Access Compliance Report

Public Rights-of-Way

Intersection ID: 14611	Main Street: CIRCLE_AV	Cross Street: S_CHASE_ST	Location: N
ADA ID: E177D685D0E1	Ramp Type: PerpDiag	Initial Pass/Fail: Pass	Overall Compliance: No
			Severity Score: 12.75

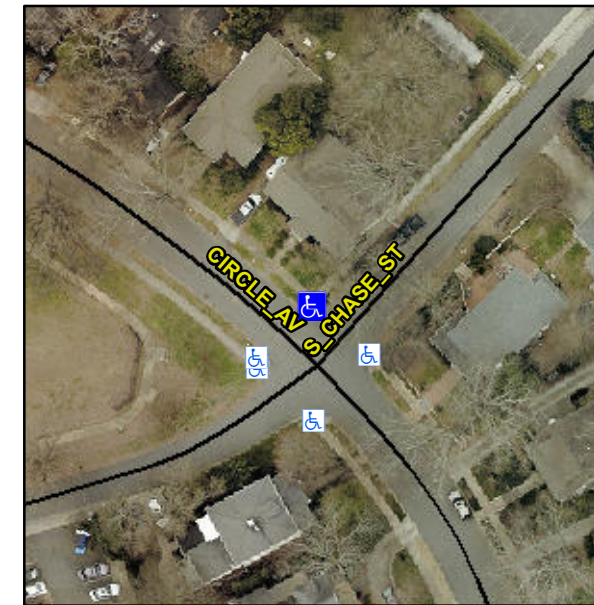
R304.5.3, R304.2.1, R304.2.2-Perp, R304.3.2-Para, R305.1.4, R305.2

Compliance	Description	Data	Compliance	Description	Data
N/A	Ramp Length (in)	98.0	Yes	Ramp Slope (%)	5.8
Yes	Ramp Width (in)	48.0	No	Ramp XSlope (%)	3.3
N/A	Flare Type LT	Sloped	N/A	Flare Type RT	N/A
N/A	Flare Slope LT (%)	2.8	Yes	Flare Slope RT (%)	0.7
N/A	Flare Traversable LT?	Yes	N/A	Flare Traversable RT?	Yes
No	Landing Length (in)	N/A	Yes	DWS Provided?	Yes
No	Landing Width (in)	N/A	Yes	DWS Contrast?	Yes
No	Landing Slope (%)	N/A	Yes	DWS Length (in)	25.5
No	Landing X Slope (%)	N/A	No	DWS Full Width?	No
N/A	Landing Curb? (Y/N)	No	No	DWS Offset (in)	6.0
N/A	Shared Landing?	N/A			
Yes	Gutter Ponding?	No	Yes	Gutter Slope (%)	3.3
Yes	Gutter Lip Ht (in)	0.0	Yes	Gutter X Slope (%)	0.1
N/A	Painted X Walk1?	No	N/A	Painted X Walk2?	No
	X Walk 1 Direction	To SW		X Walk 2 Direction	To SE
N/A	X Walk 1 Width (in)	N/A	N/A	X Walk 2 Width (in)	N/A
	X Walk 1 Slope (%)	6.3		X Walk 2 Slope (%)	1.1
	X Walk 1 X Slope (%)	1.8		X Walk 2 X Slope (%)	2.3

Remove & Replace Curb Ramp With Two New Directional Ramps or Equivalent.
